Contract No. T200411209.01
Federal Aid Project No. ESTP-S028(8)
SR 24, Mulberry Knoll to SR 1
Sussex County

Enclosed is Addendum No. 1 for the referenced contract consisting of the following:

Addendum No. 1
October 24, 2019

CP-06
SECTION: AEC
SHEET NO.: 18

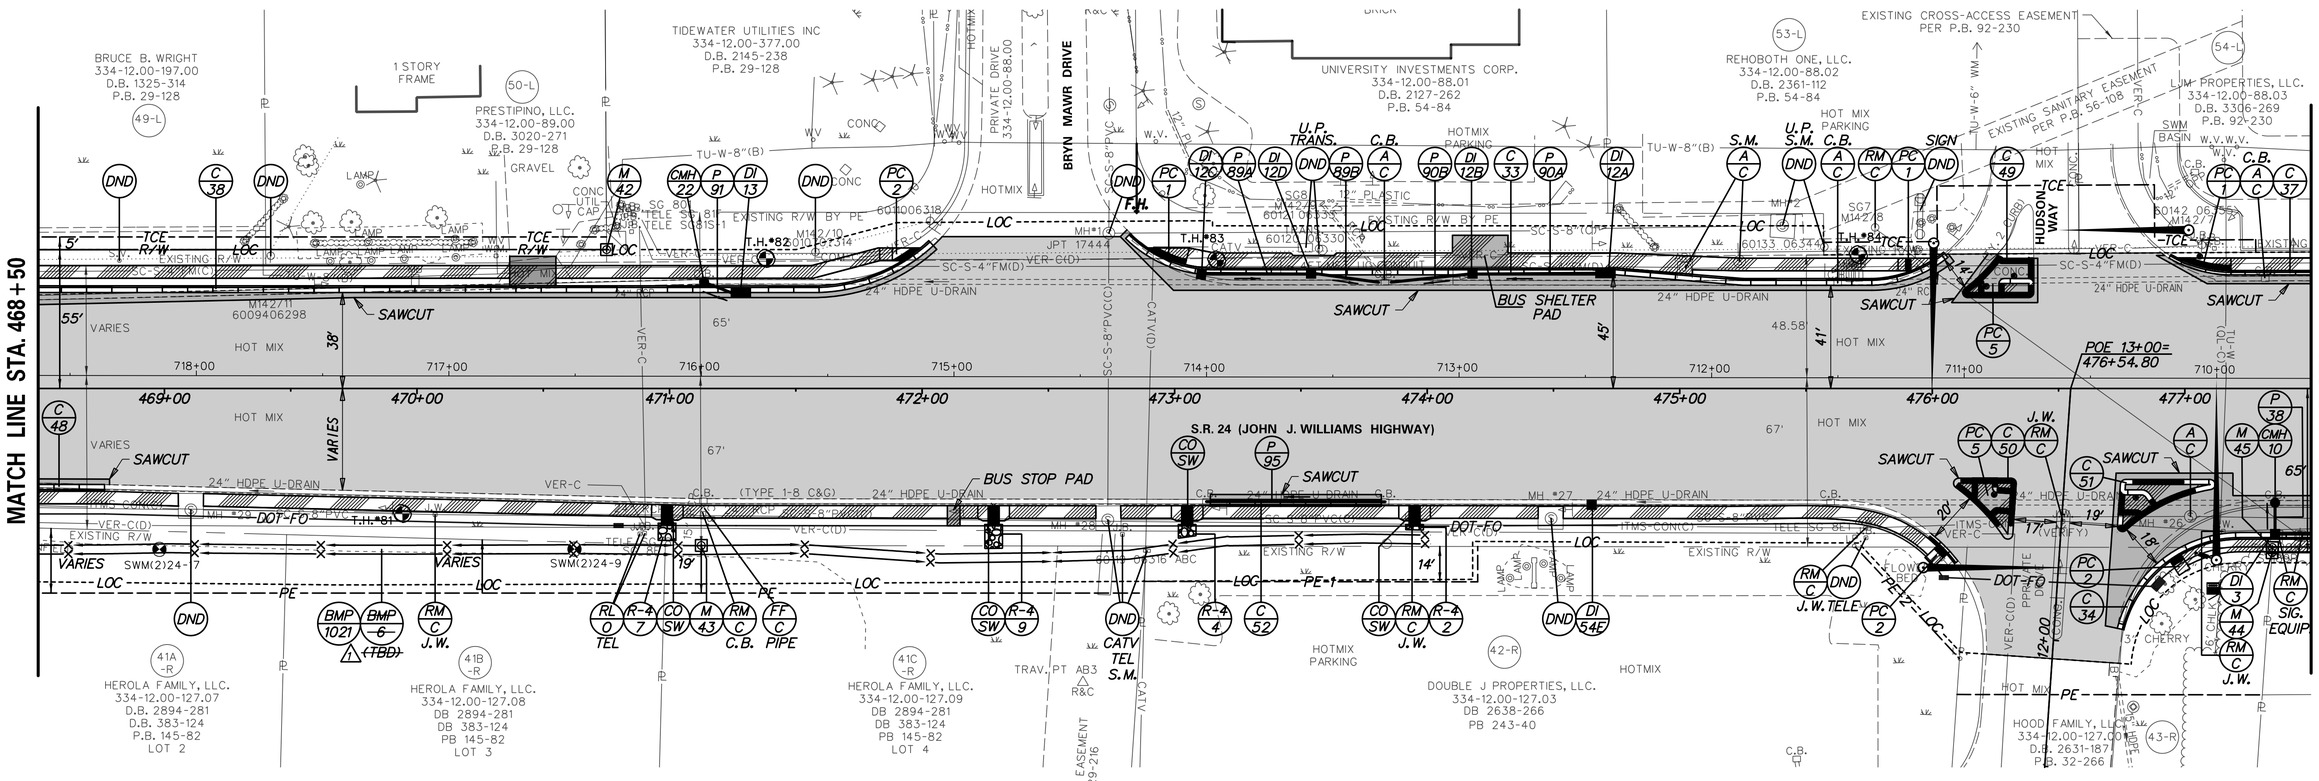
1 REVISED BMP NUMBERS AND DESCRIPTIONS — D. SEMPLE 10/03/2019

SECTION	SHEET NO.
AEC	20

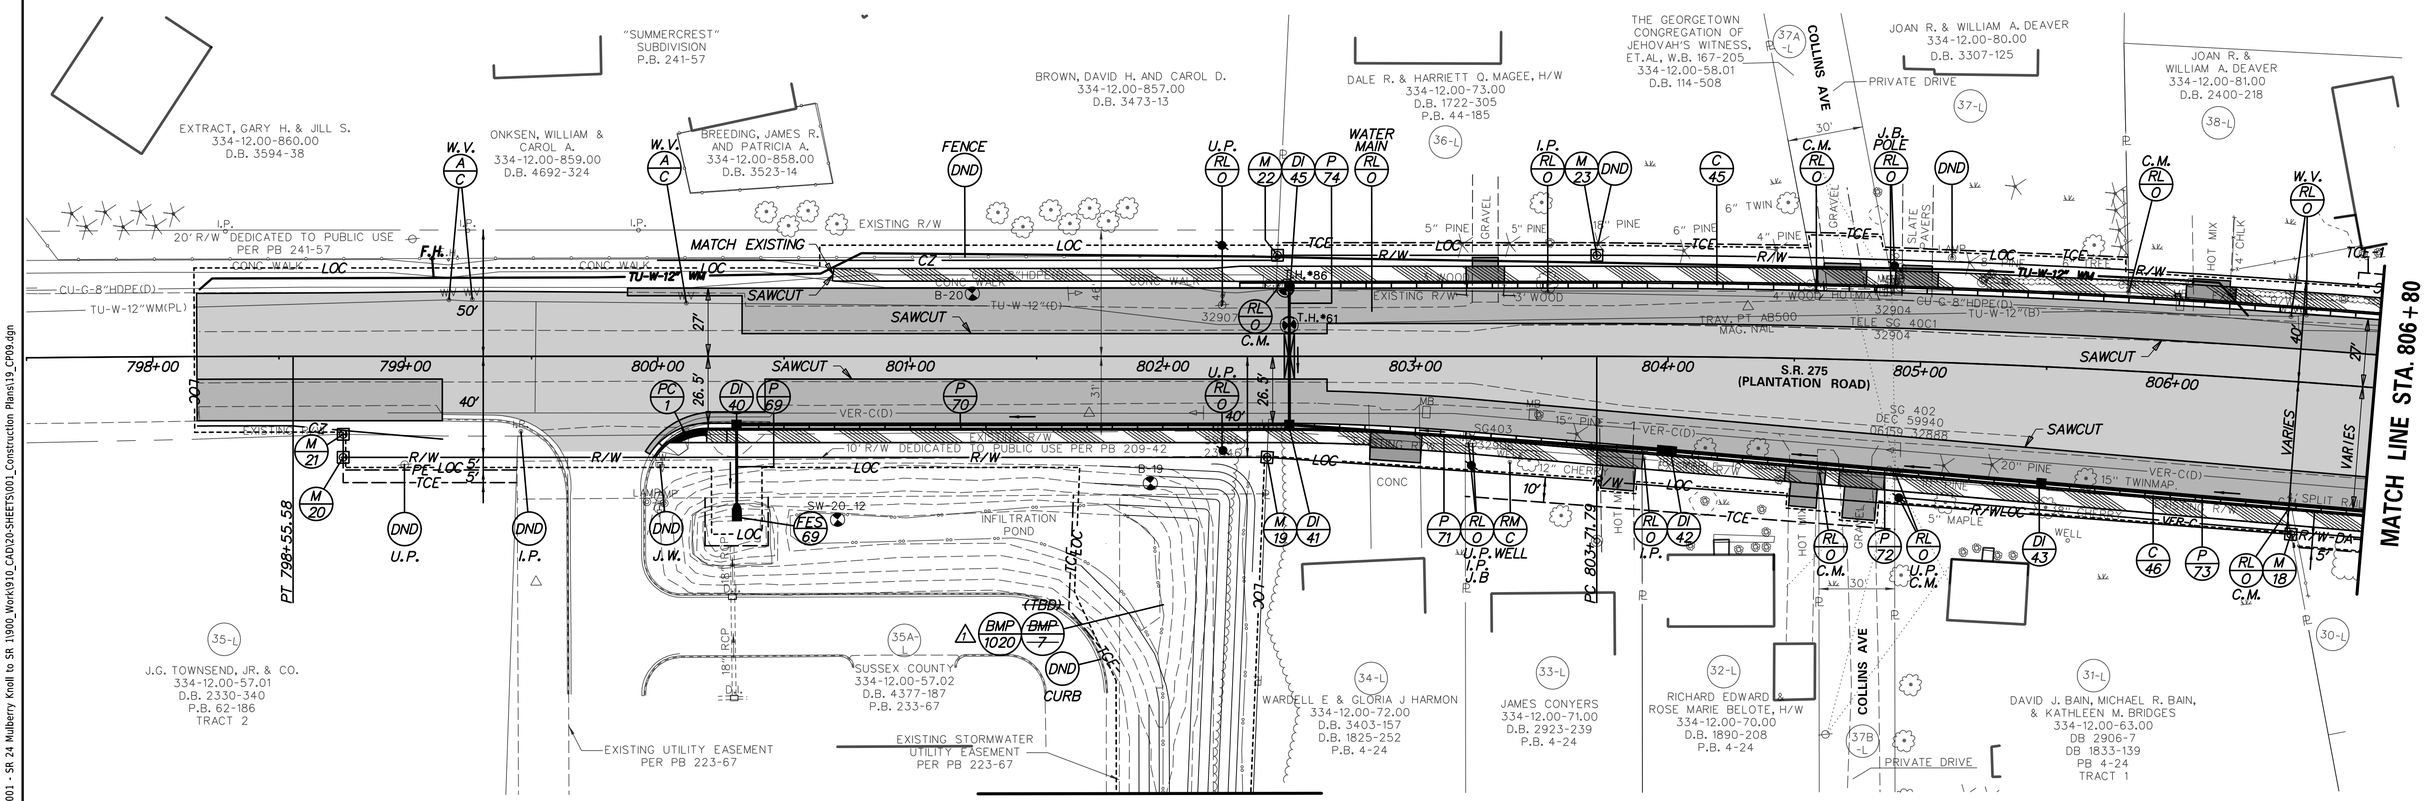
1 REVISED BMP NUMBERS AND DESCRIPTIONS — D. SEMPLE 10/03/2019

CP-10
SECTION
AEC
SHEET NO.
22

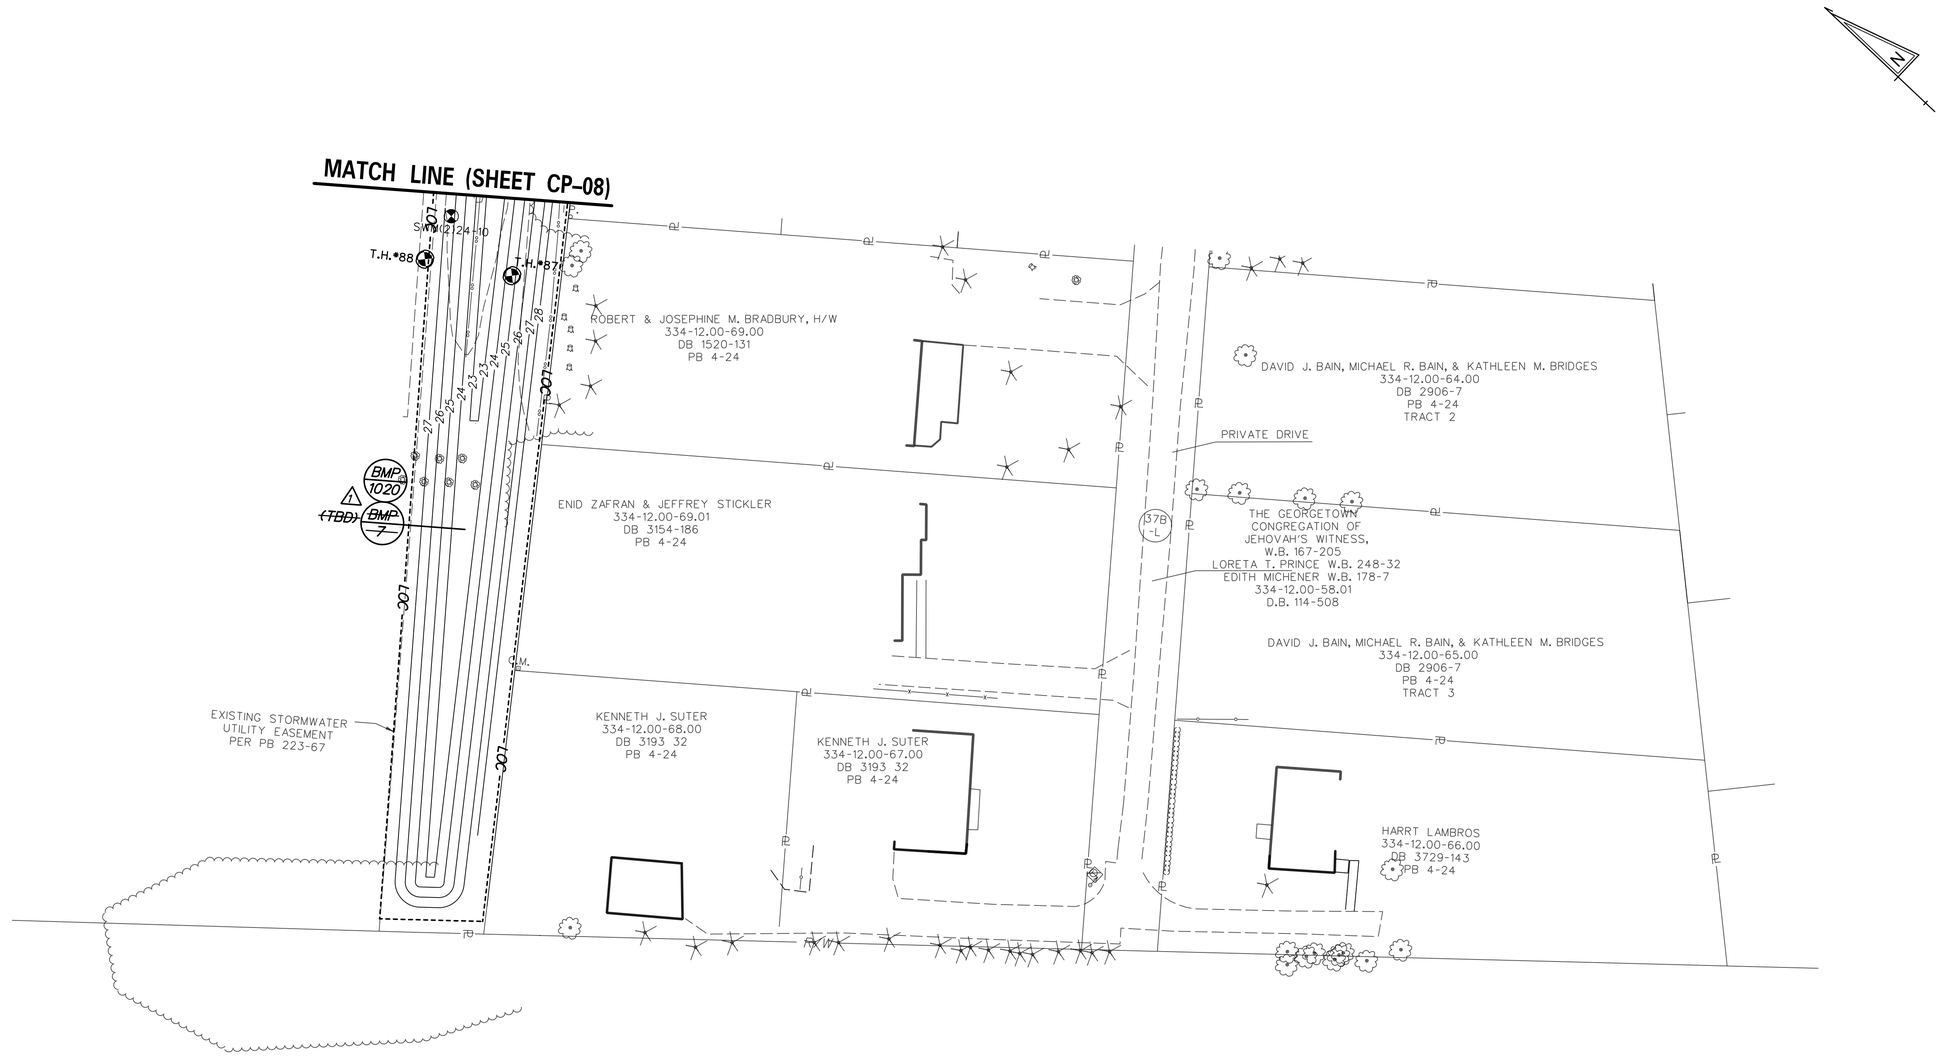
1 REVISED BMP NUMBERS AND DESCRIPTIONS — D. SEMPLE 10/03/2019

SECTION	SHEET NO.
AEC	30

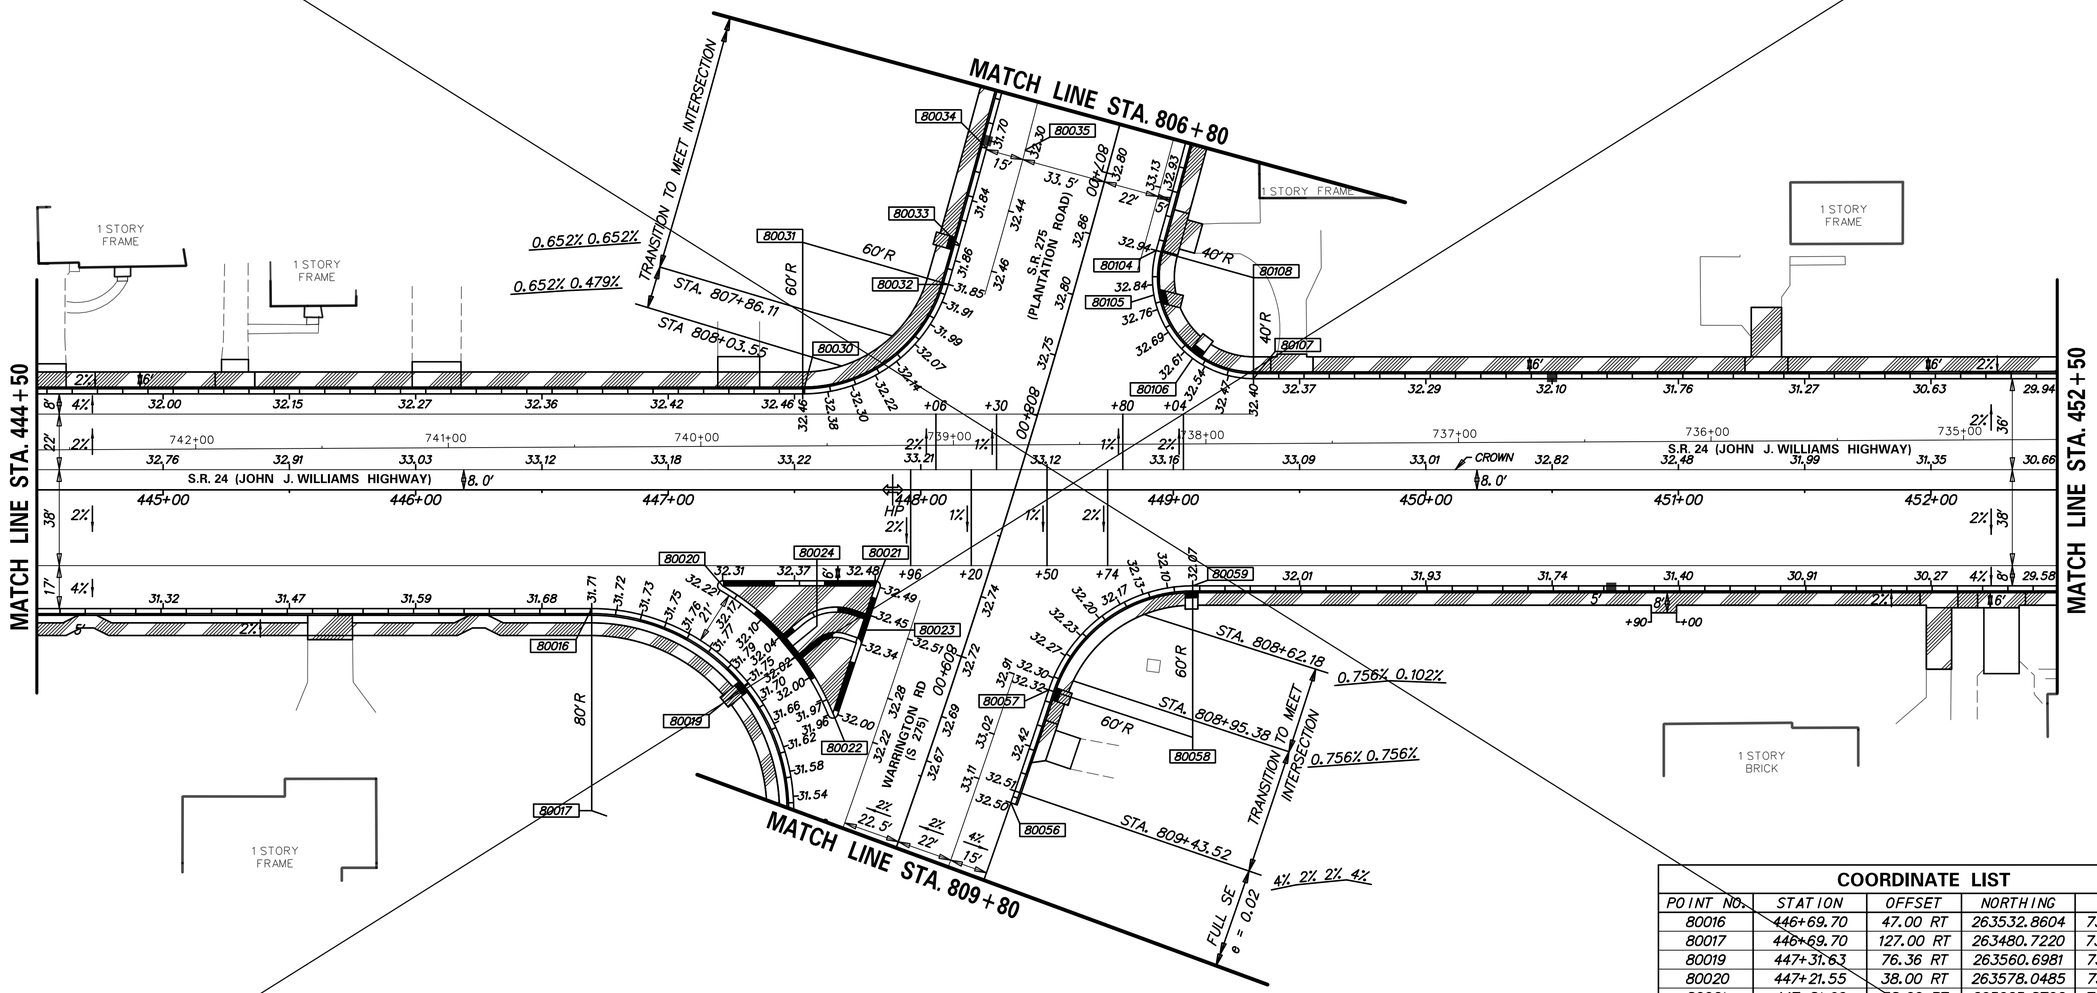
1 REVISED SIDEWALK WIDTH FROM 6' TO 5' FROM STA 449+10 TO STA 451+30 LT — D. SEMPLE 10/03/2019

SHEET NO. 30A

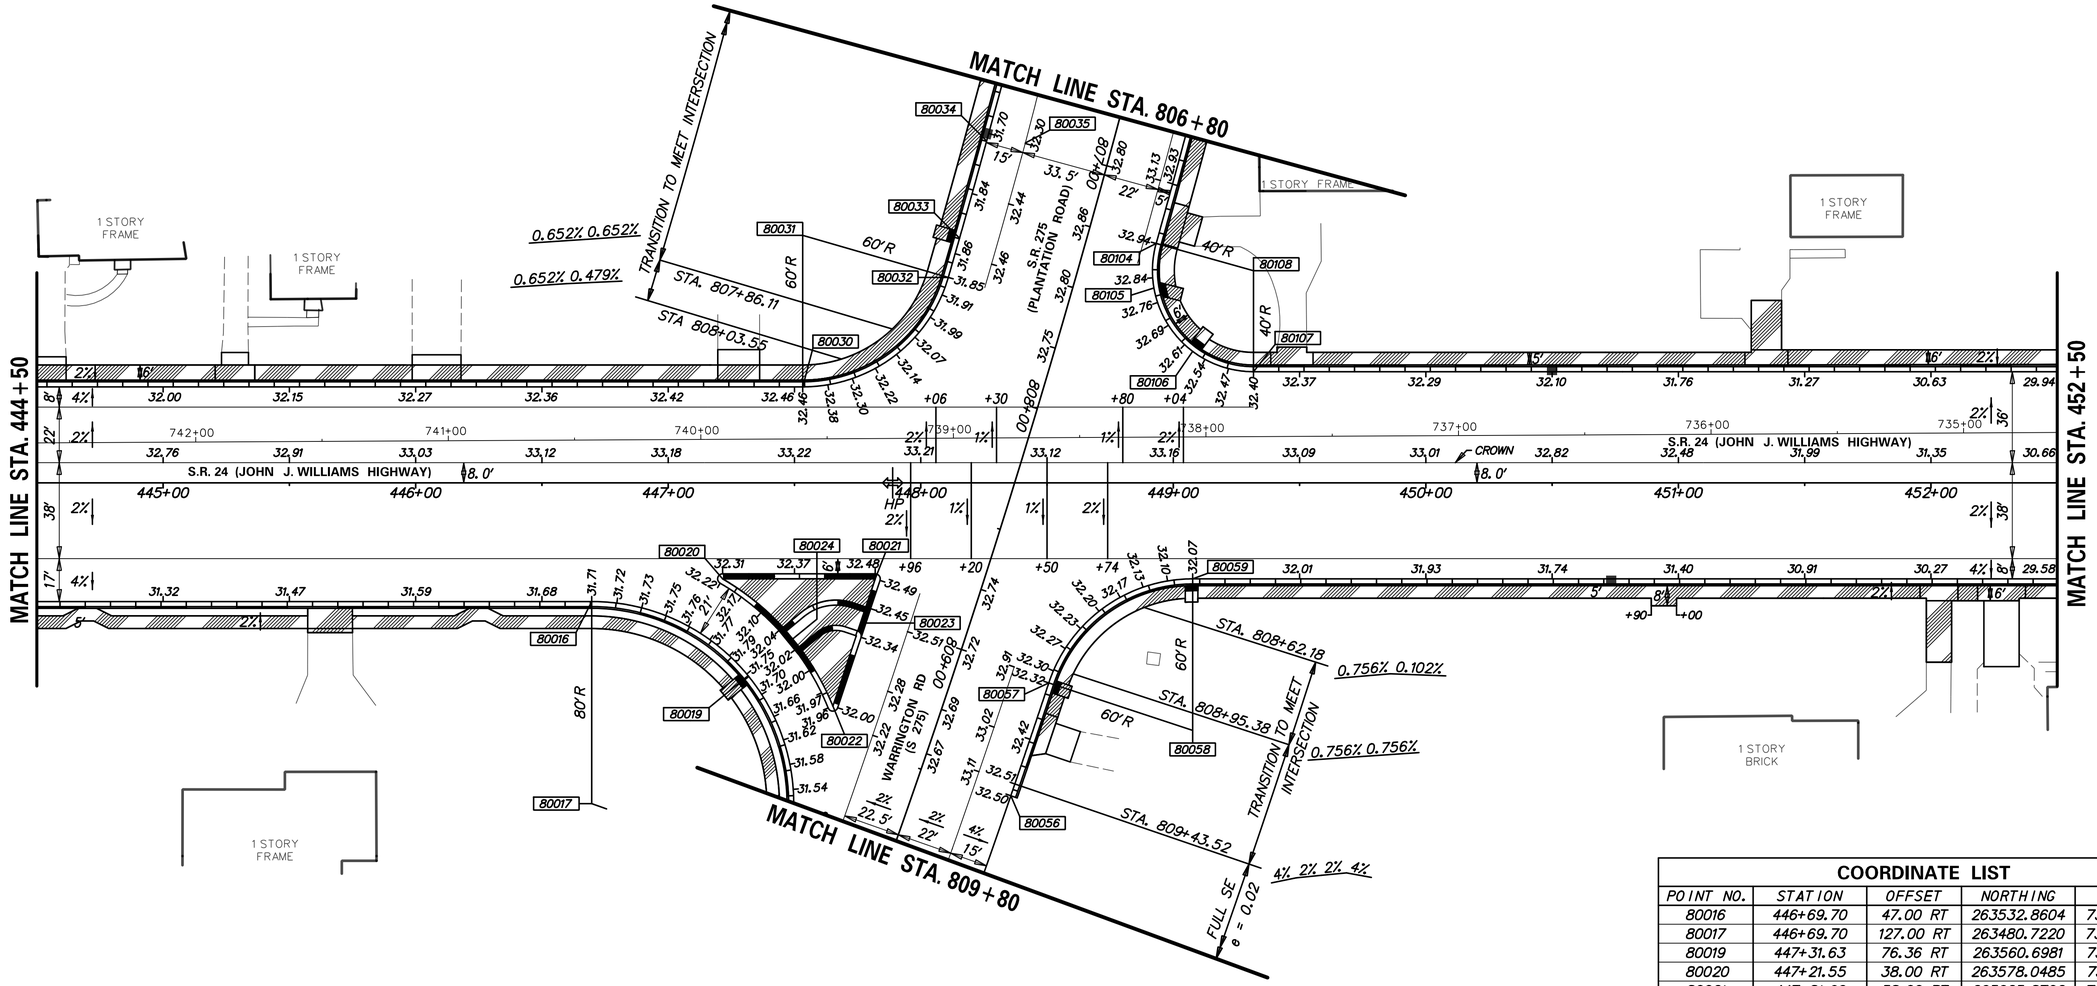
1 REVISED SIDEWALK WIDTH FROM 6' TO 5' FROM STA 449+10 TO STA 451+30 LT — D. SEMPLE 10/03/2019
